CIRCUIT COMPARISON

ChryslerScanner

Original schematic -> current circuit sets

Original: Daniel Laszlo, revision 2.4.0-1, 2026-01-05. Current: Rev C, 24 pages / 329 circuit-probe endpoints.

29 Added PCI comparator supply clamp

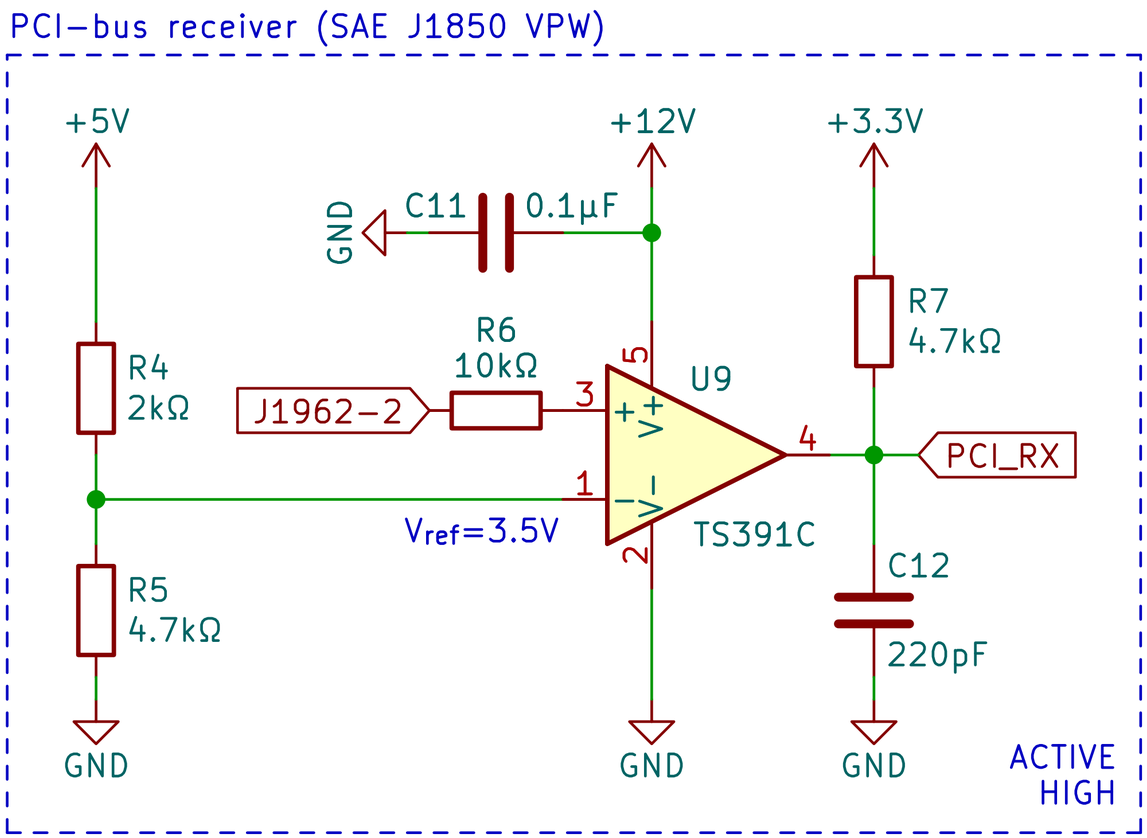
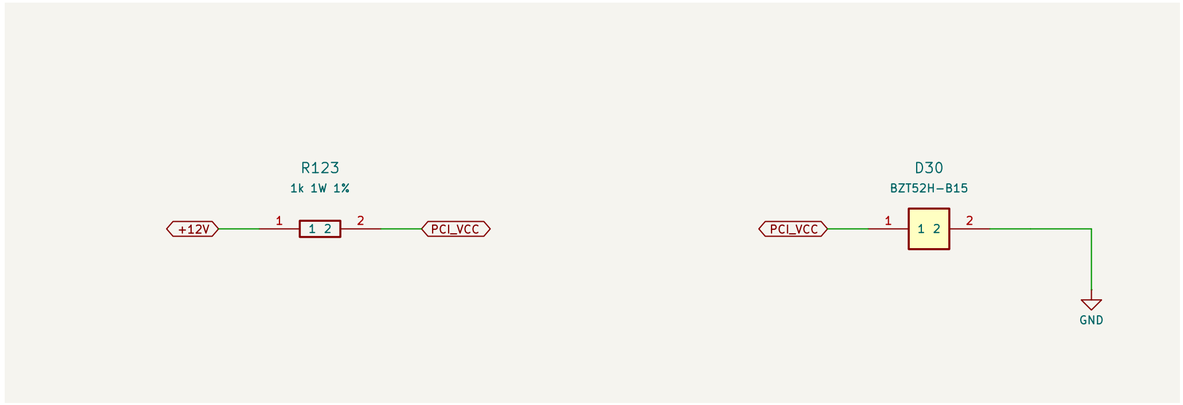
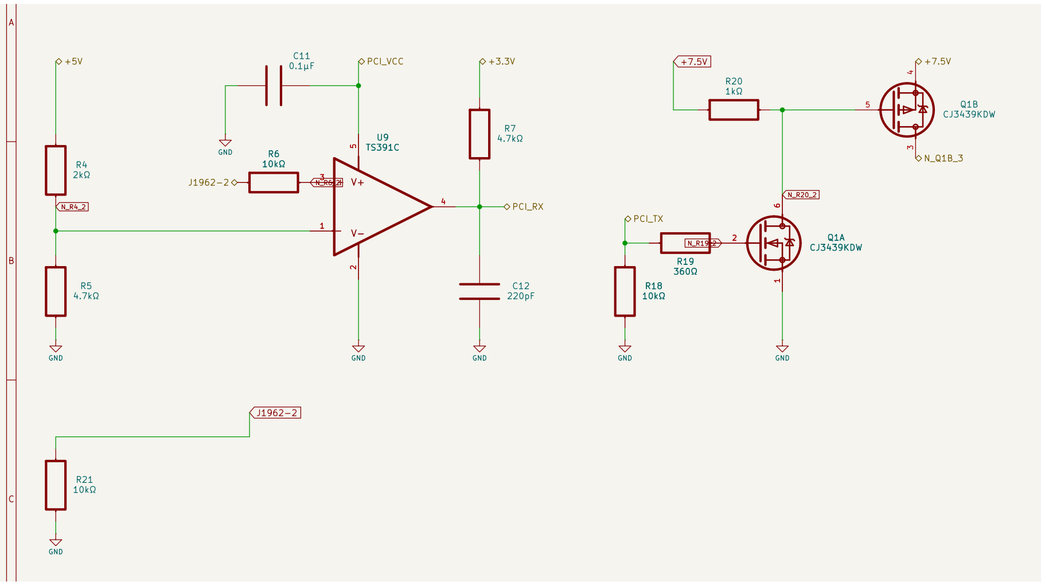
- R123 and D30 are new. U9.5 and C11.2 now use PCI_VCC rather than direct +12V.
- The original receiver function remains, while its supply protection is deliberately changed.

30 Hook test points and SPI probe pads

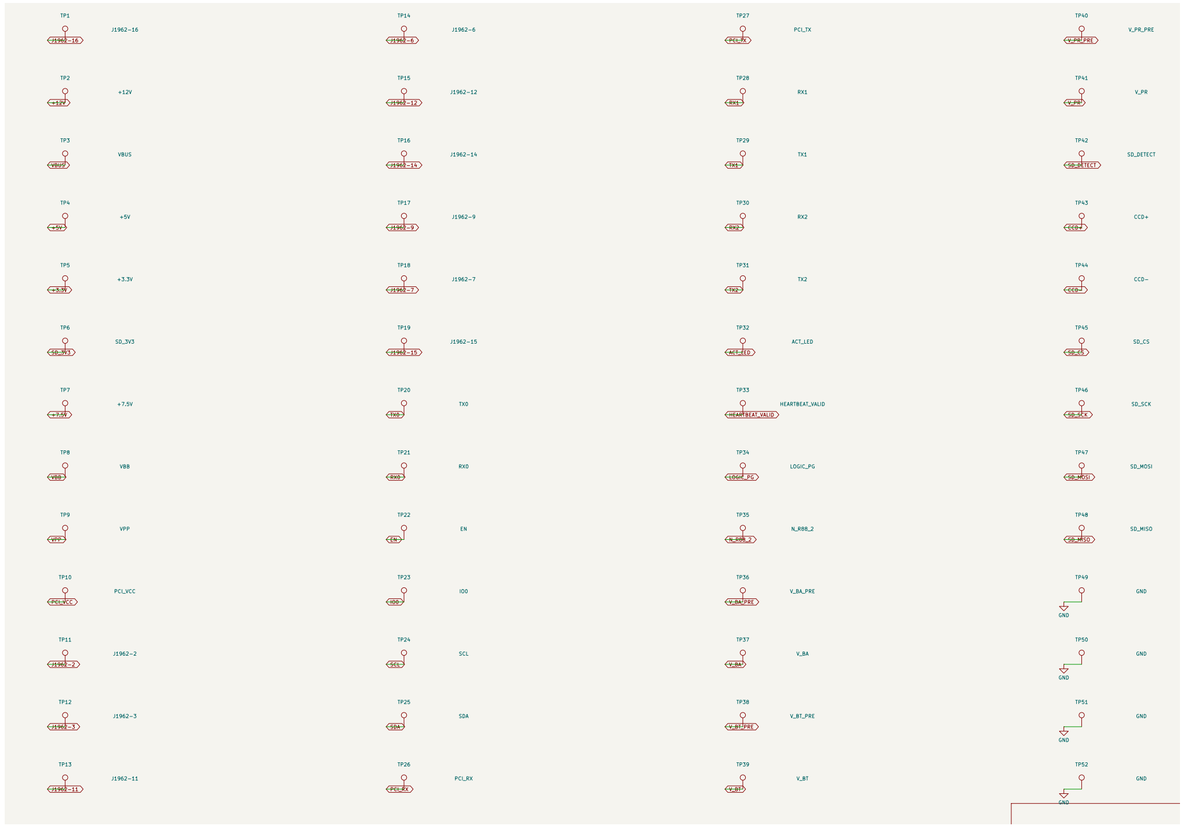
- The original PDF has no TP1-TP52 debug-access block. The current design adds 48 Keystone 5015 hook loops and four bare SPI pads, with four local ground clips.
- Page 24 and rev-c-testpoint-map.md identify every net. Existing circuit geometry is retained; new pads require 230 total filled/capped/planarized via sites in the current fabrication package.
